Local Planning Panel

117 Victoria Street, Potts Point

D/2023/862

Proposal

excerpt of rental data provided

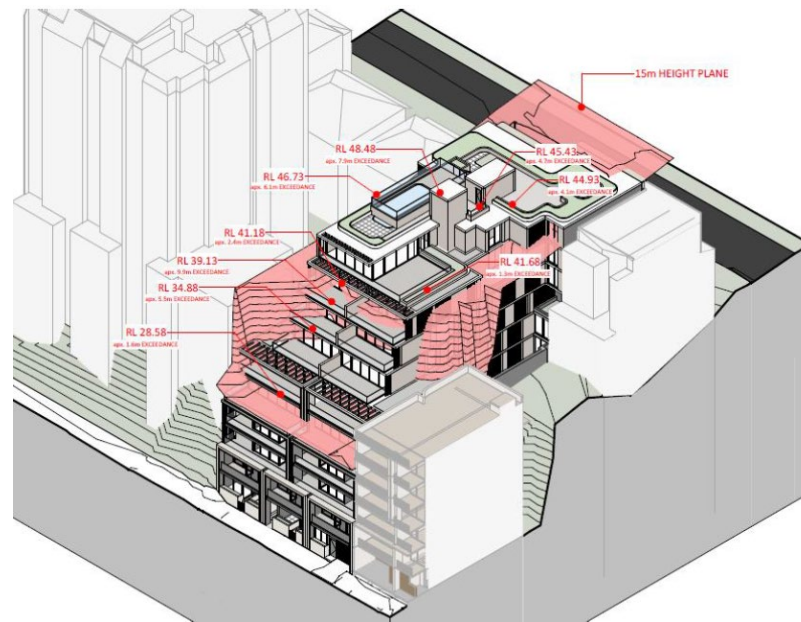
- loss of affordable housing provisions of Housing SEPP apply
- existing building includes 45 apartments (1 two bedroom, 34 one bedroom and 10 studios)
- all apartments have a rental yield below median for the last 12 months

- proposal does not adequately address Clause 47(2) of the Housing SEPP
- sufficient comparable accommodation not available in the area
- proposal results in loss of 45 existing low rental dwellings
